# UNITED STATES PATENT AND TRADEMARK OFFICE

APPLICATION NO.	FILING DATE	FIRST NAMED INVENTOR	ATTORNEY DOCKET NO.	CONFIRMATION NO.
10/754,591	01/12/2004	Itzhak Hadar	27226	8026

# Office Action Summary

**DETAILED ACTION**

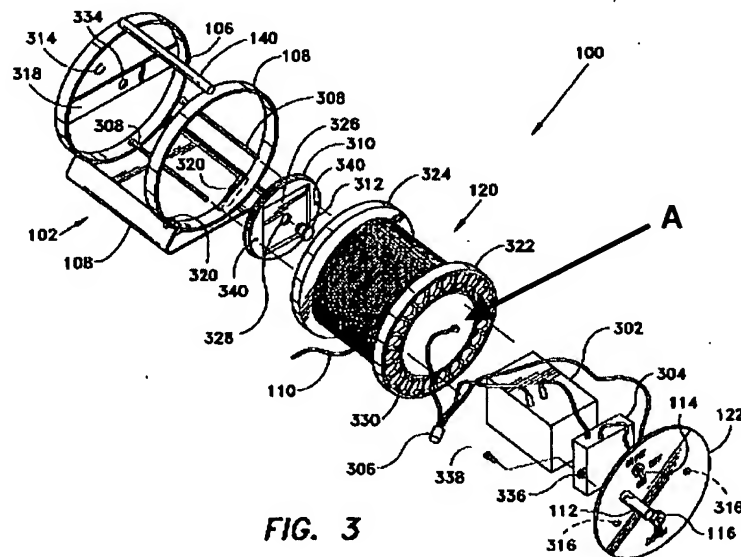
2. Claims 1-8, 13, 17-20 are rejected under 35 U.S.C. 102(e) as being anticipated by WOODRUFF (US 6,758,314), which provides:

- A reel/drum constructed for winding a visible-light emitting electroluminescent cable on an outer surface (120);
- An electroluminescent cable wound on said reel (110);
- A support member rotatably supporting said reel such as to permit said electroluminescent cable to be deployed therefrom (102);
- A self-contained power supply/rechargeable battery providing DC voltage carried with said reel/drum, located on one side of said drum and rotated therewith (302, Column 3, Lines 61-62, Fig. 3);
- A DC to AC power inverter mounted inside drum opposite battery (304, Column 3, Lines 62-63, Fig. 3);
- A lead-through opening formed in the drum outer surface for electric connection (Ref. A; Fig. 3 below)

- A drum cover (310) having a central shaft for rotatably mounting said drum (312) and an opposite, battery-access, removeably attached cover (122) having a manual-electrical switch (114), an electric plug for recharging battery (116) and a handle mounted on its outer periphery for rotating said drum (112);
- A pair of legs for resting the reel on a flat surface (either side of 108); and
- A mounting plate having attaching elements engageable with said legs for attaching/detaching said reel with respect to said mounting plate (104/106).
